# intel® Technical Advisory

TA-0739-01

## Slim-line CDROM Drive Trays Stick when Opened

Slim-line CDROM assembly for fixed drive configurations

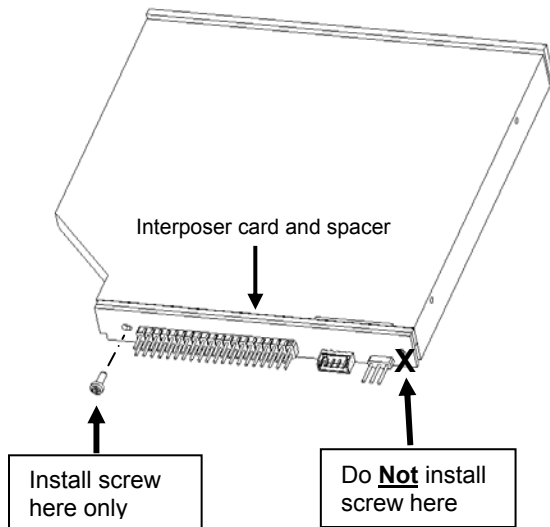
From shock and vibration test results, Intel has determined that the use of a single screw can be used to attach the interposer card and spacer to the slim-line CDROM drive. See Diagrams below.

Intel has included modified assembly instructions with each of the product revisions listed above that have a build date after November 24, 2004. Build dates can be found on the White Product Label affixed to the product's outer packaging. The modified assembly instructions will advise customers to use one screw to attach the interposer card and spacer to the slim-line CDROM drive.
